Request For Information RFI-097

Subject: BP3 Art and Brand Wall Supplemental Steel
Project: Steamboat - BV BP Promenade and Goldwalk
Address: 2305 Mount Werner Circle
Steamboat Springs CO 80487 USA
Phone:
To: Bryan Sculthorpe
Saunders Construction, LLC
From: Saunders Construction, LLC

Ref attached correspondence and bootleg drawings sheets, the supplemental steel for the Goldwalk and Artwall is required to be included in BP3 Goldwalk scope.

1 ART WALL SECTION

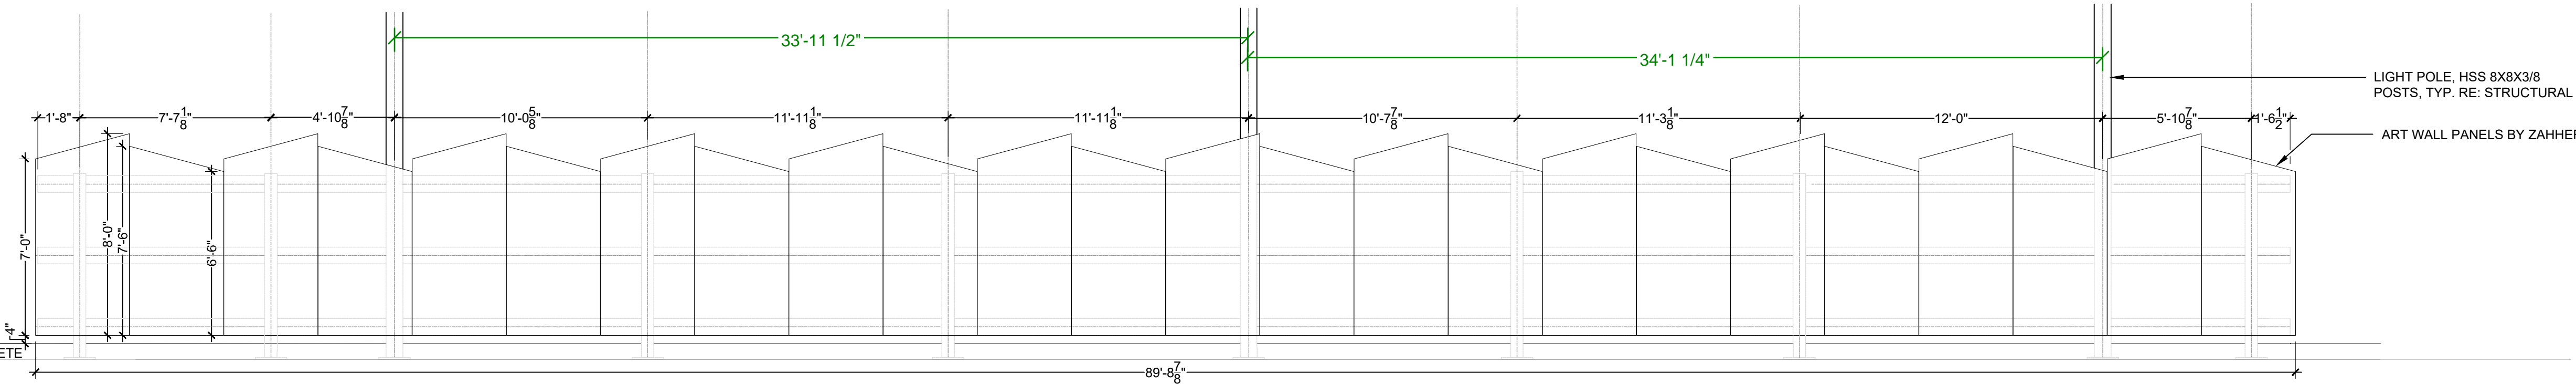
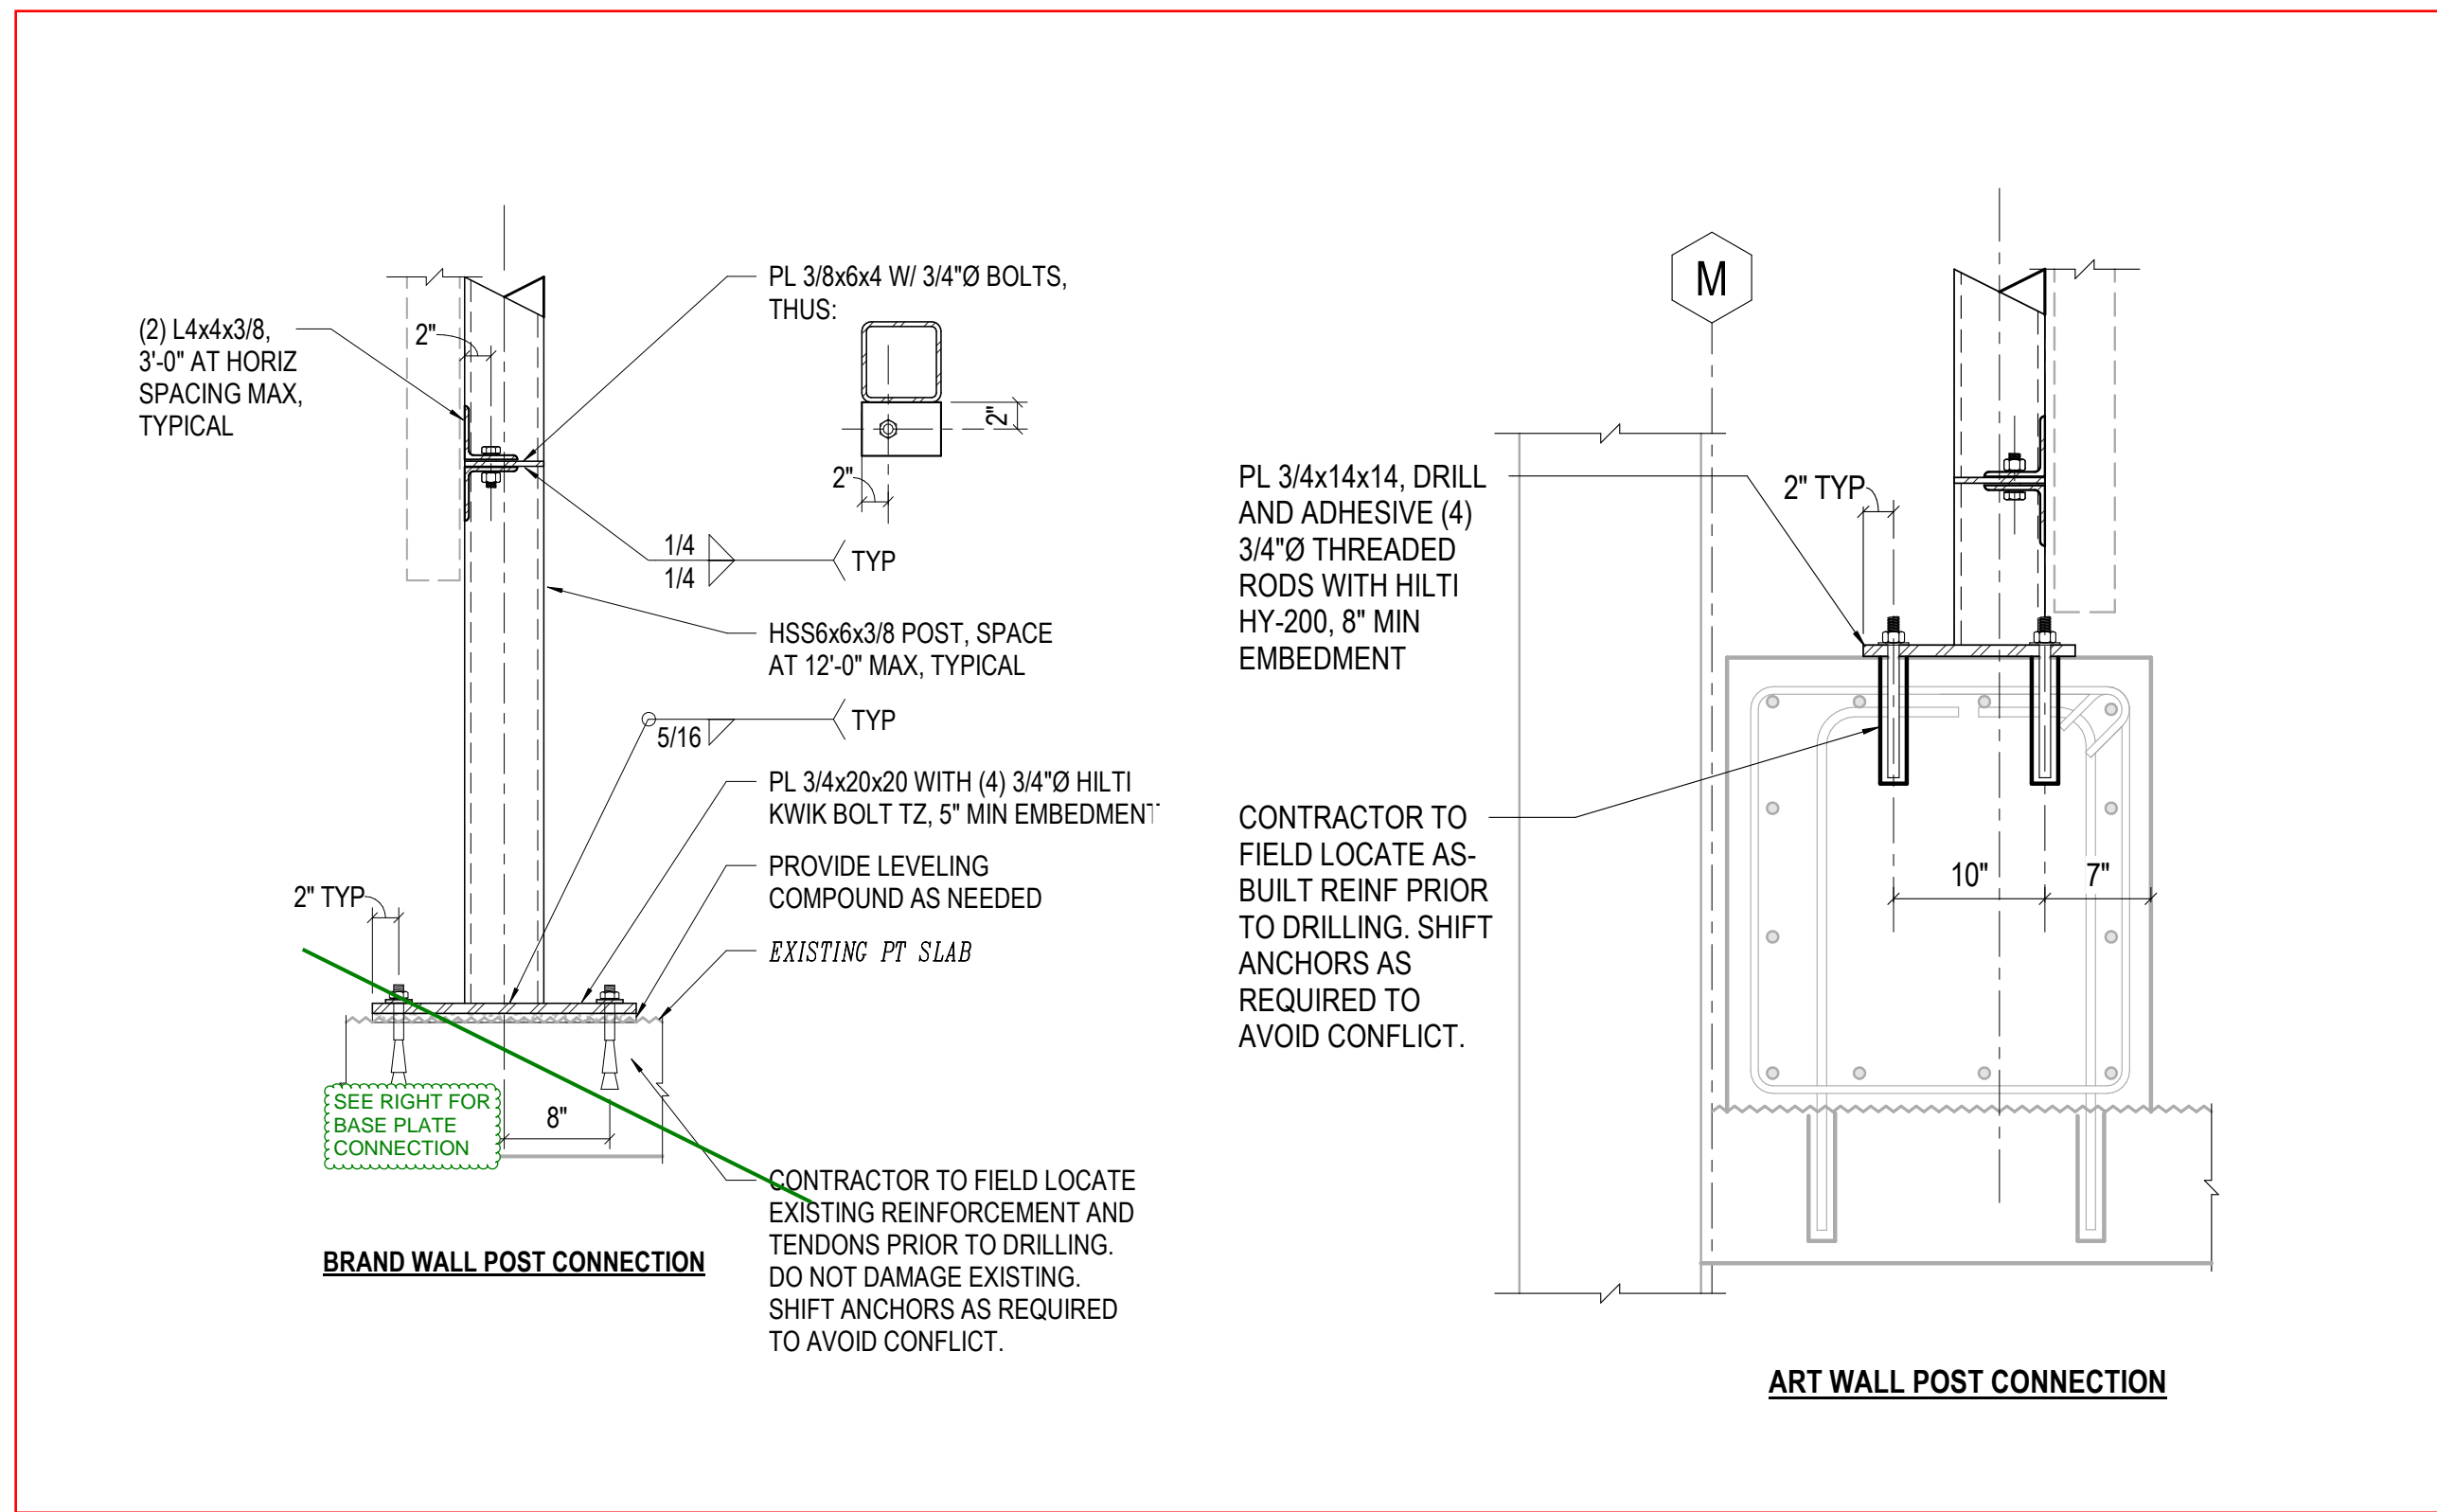
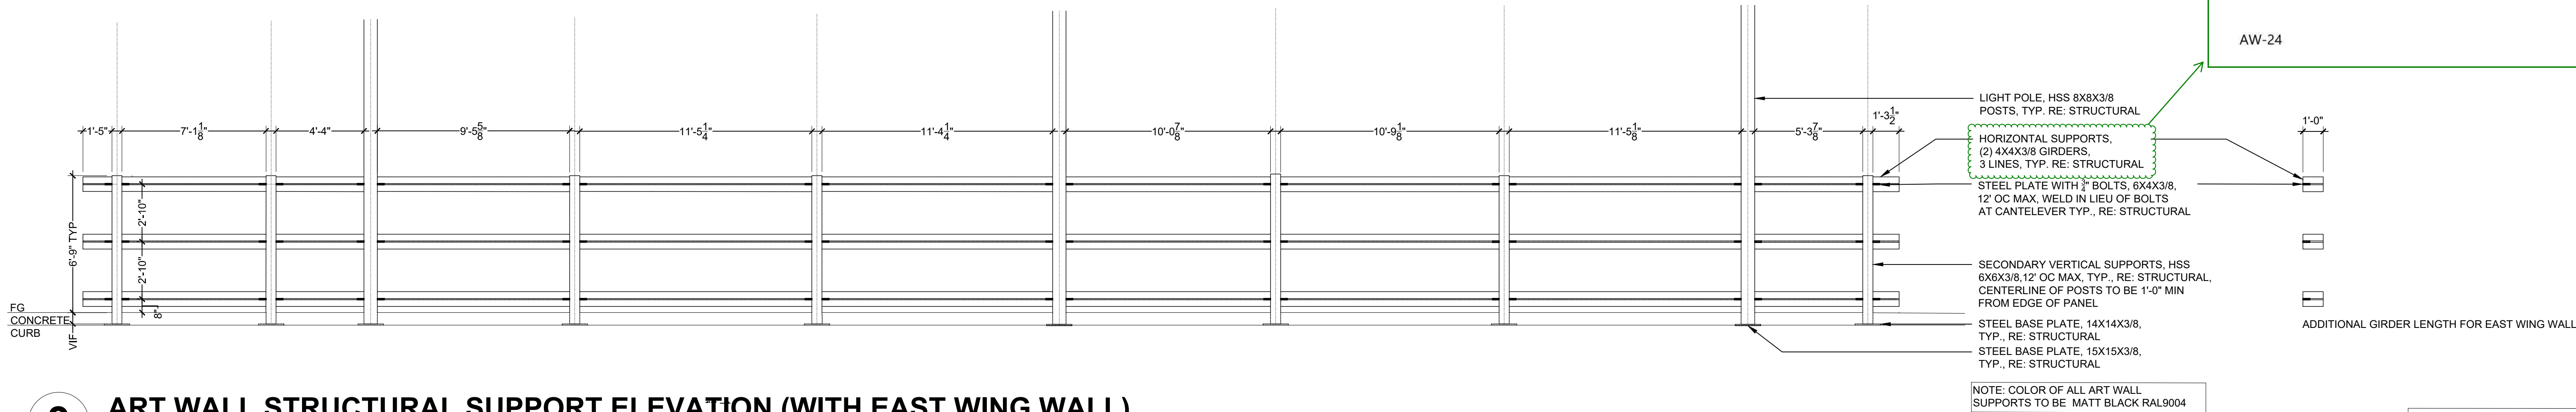
Please confirm bootleg supplemental steel package should be included in scope. If so- please provide updated construction documents that are reflective of additional supplemental steel required.

DW HAS UPDATED OUR BP3 GOLDWALK DRAWINGS TO REFLECT THE REQUIERED SUPPLEMENTAL STEEL TO SUPPORT THE ART AND BRAND WALLS. ADDITIONALLY, WE HAVE UPDATED THE LIGHTING SCHEDULE AND LIGHTING PLAN TO INCLUDE THE F6 FIXTURES. REVISED DRAWINGS INCLUDE: L0-04 GENERAL INFORMATION, L3-01 MATERIALS PLAN, L4-01, L6-01 LIGHTING PLAN, L7-02 ART WALL DETAILS, L7-03 BRAND WALL DETAILS.
SCARROLLA, DW, 10/01/21
